PUR-1378
ADDENDUM NO. 2
INVITATION TO BID

THE MARYLAND THEATRE EXPANSION
IN HAGERSOWN, MARYLAND

DATE: Monday, March 26, 2018

A-6.11
2/15/18
BID SET

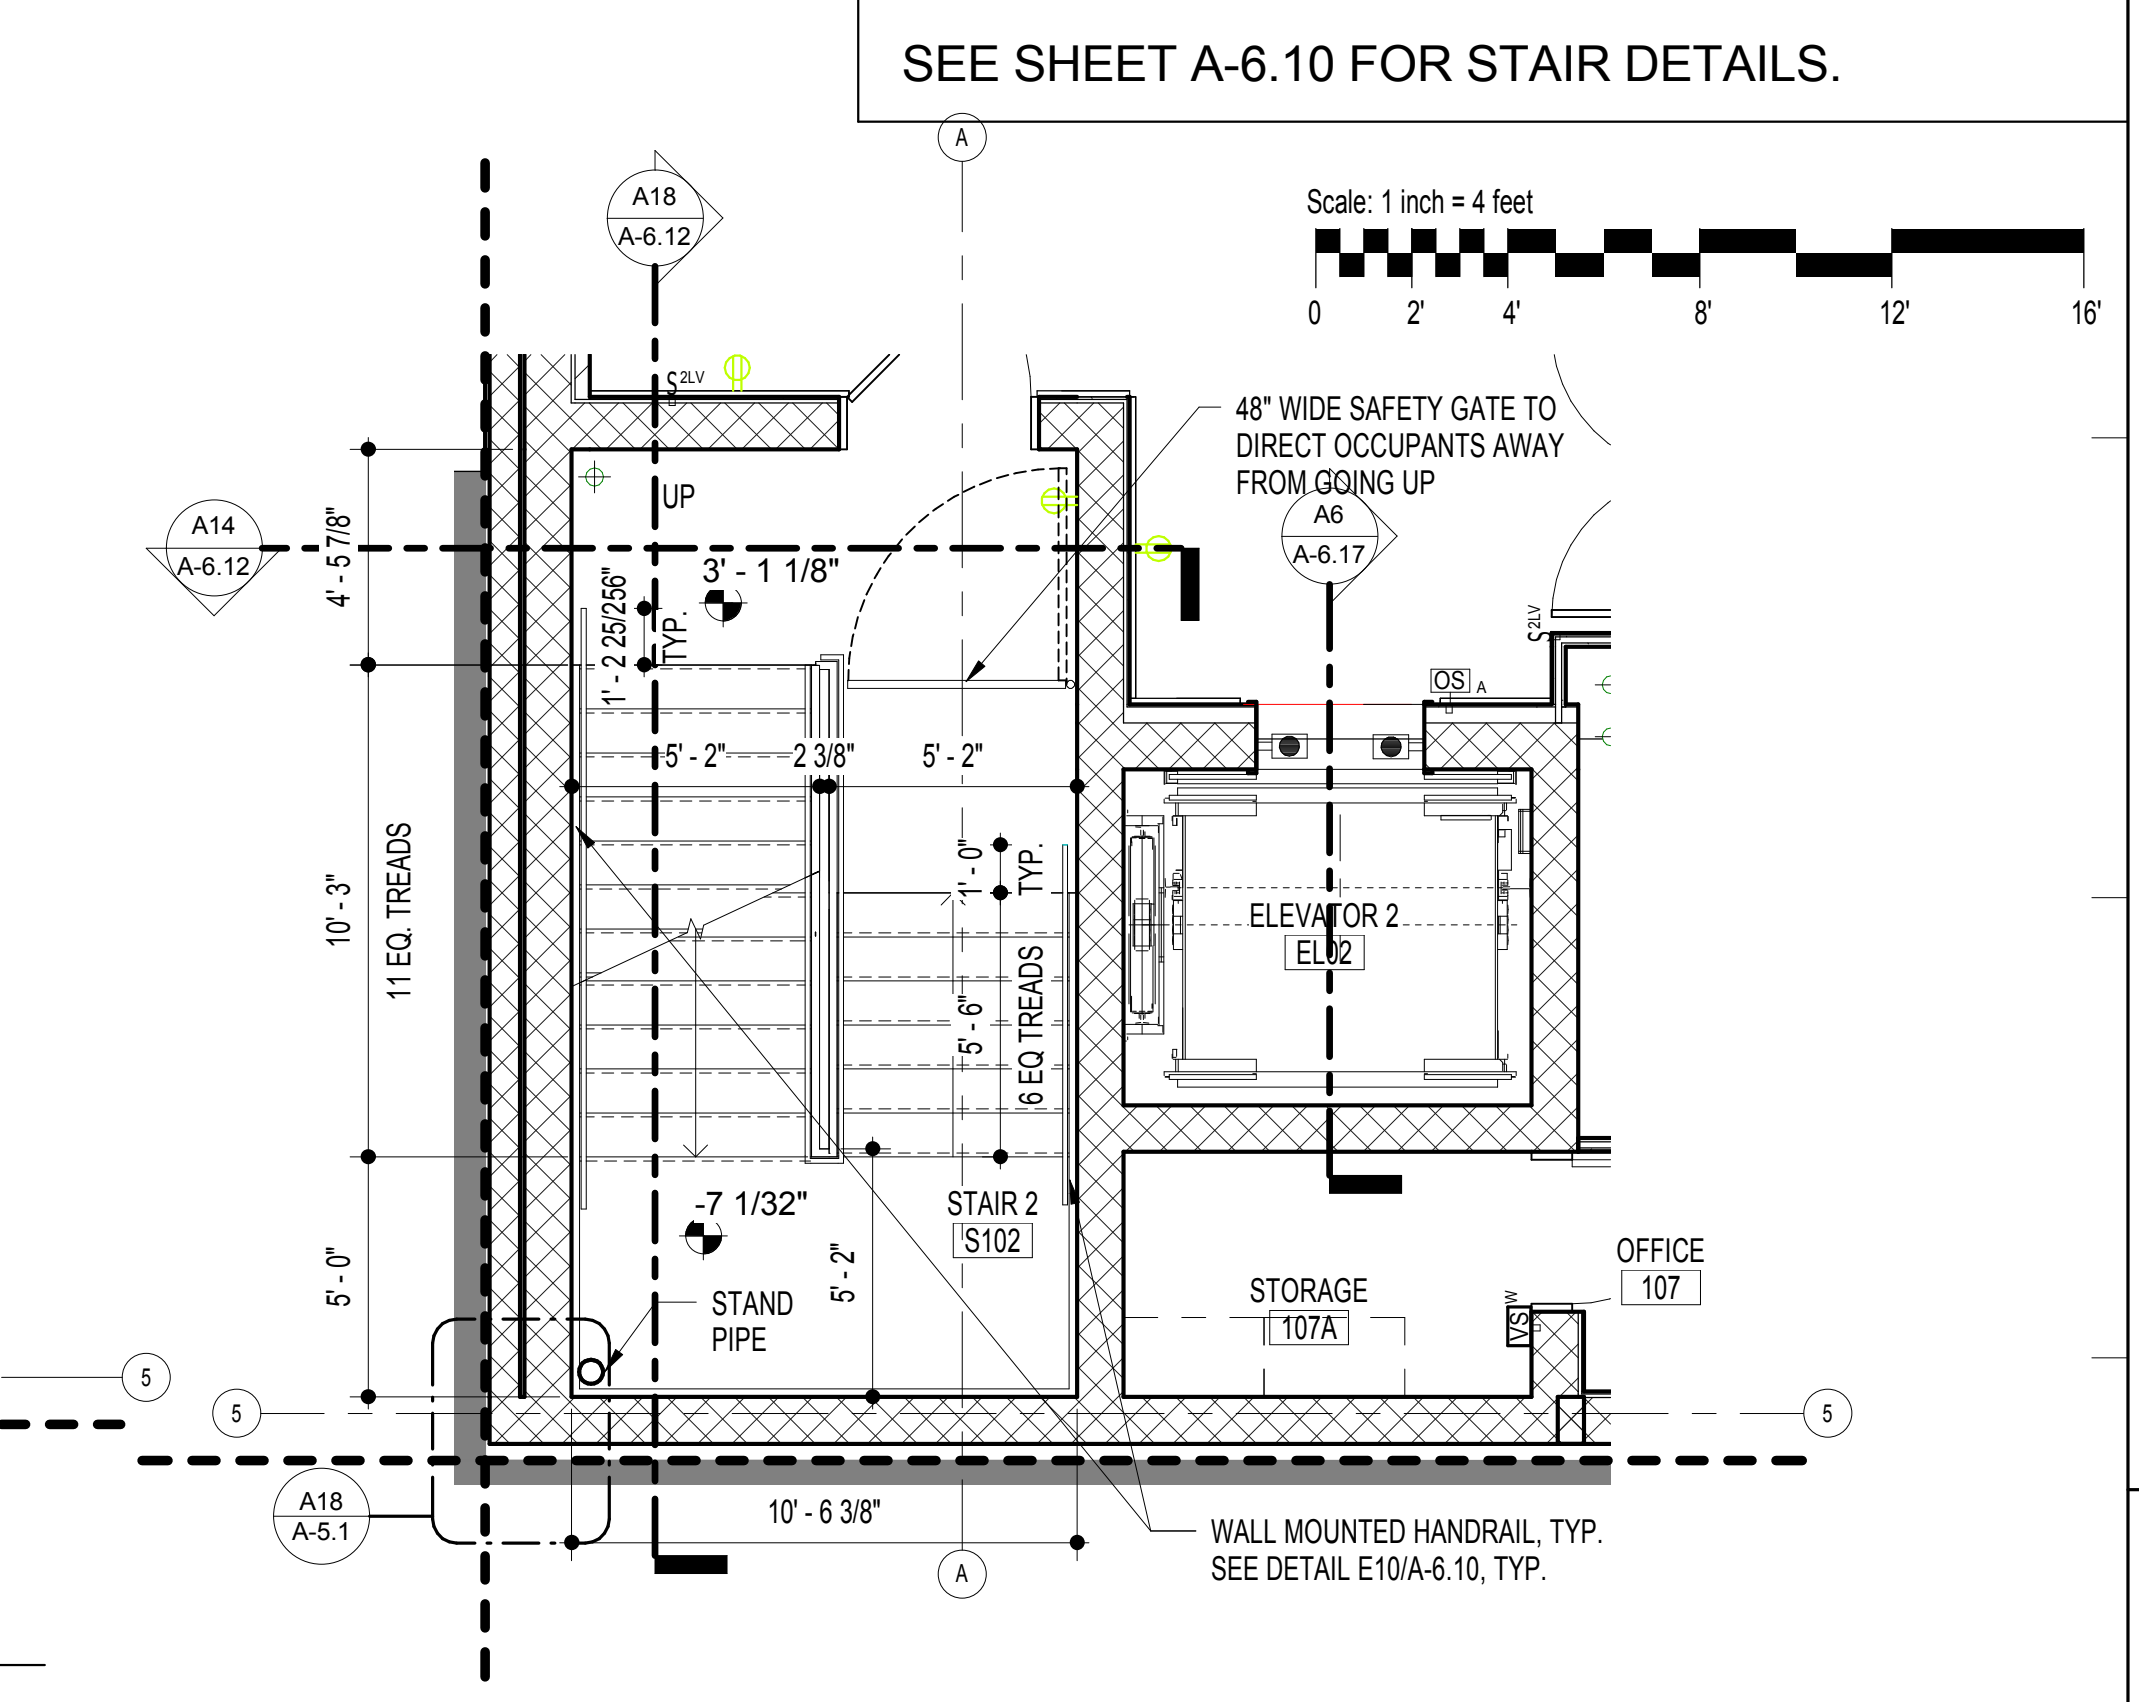
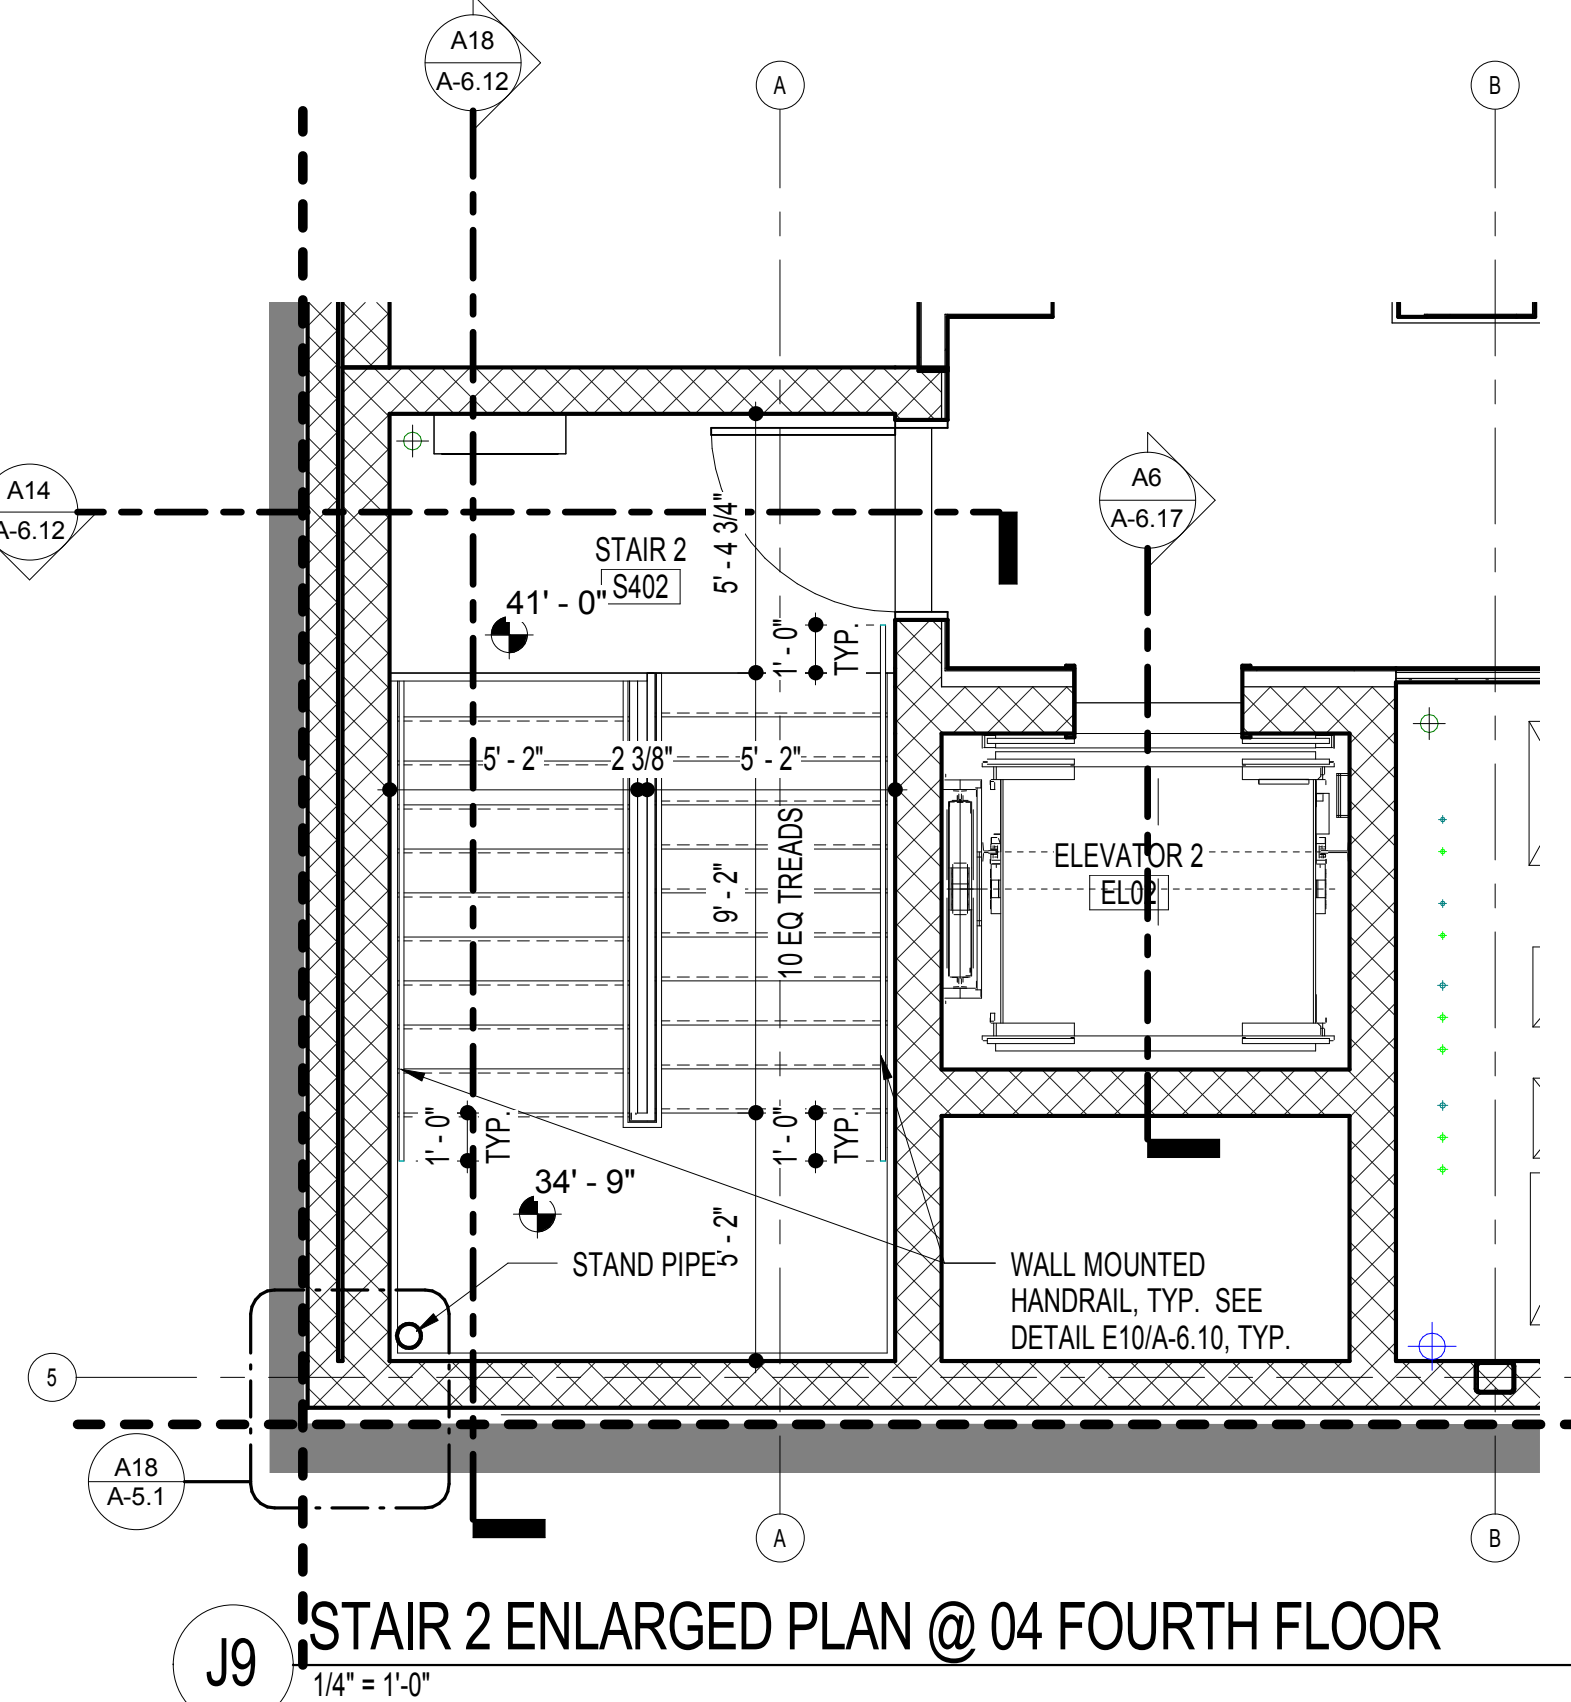
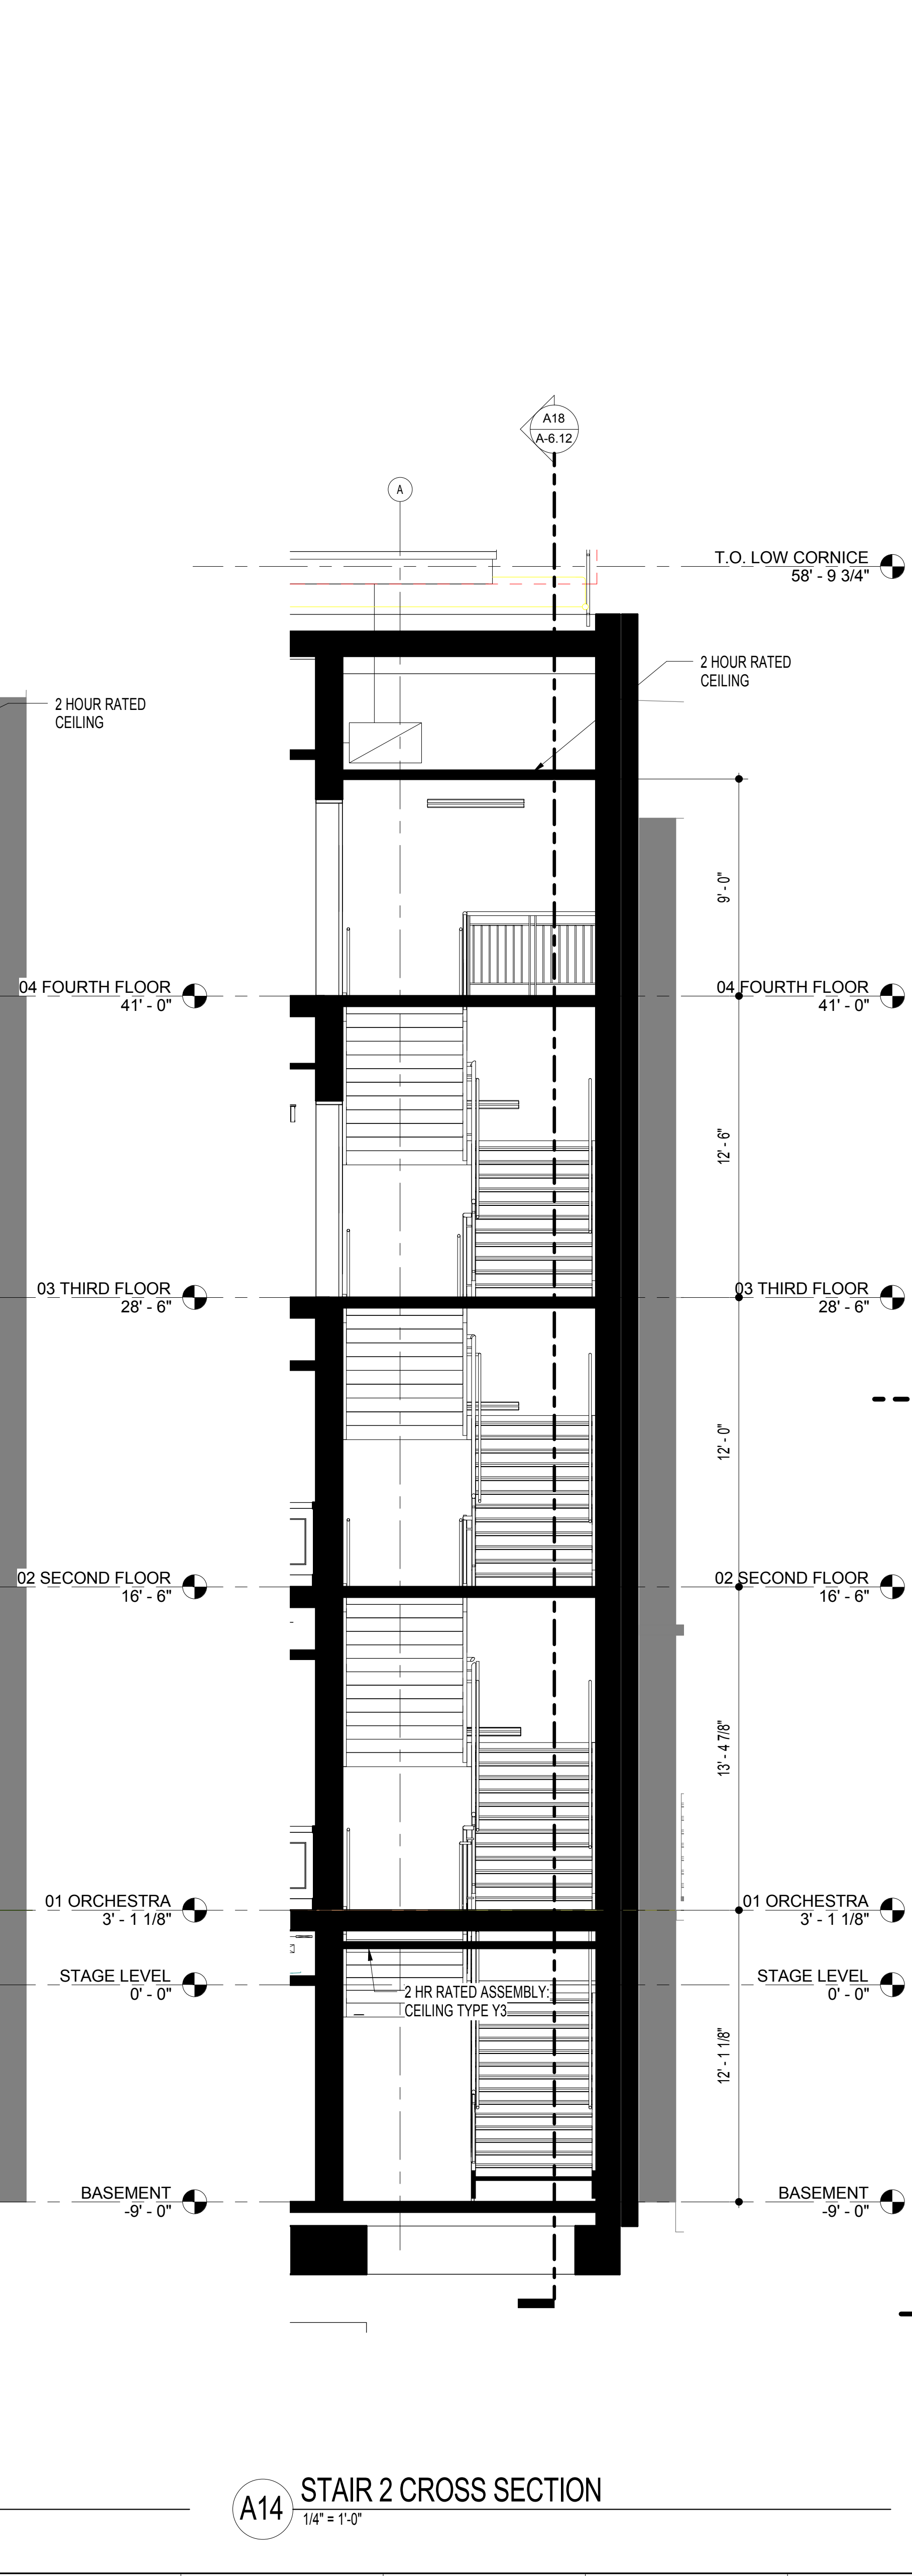
- ITEM NO. 100** SHEET A-6.11– STAIR 1 PLANS AND SECTIONS *(SHEET ATTACHED)*
- REMOVE** Remove 2 risers at Stair 1 to accommodate sidewalk elevations
- REVISE** Center Door EX100
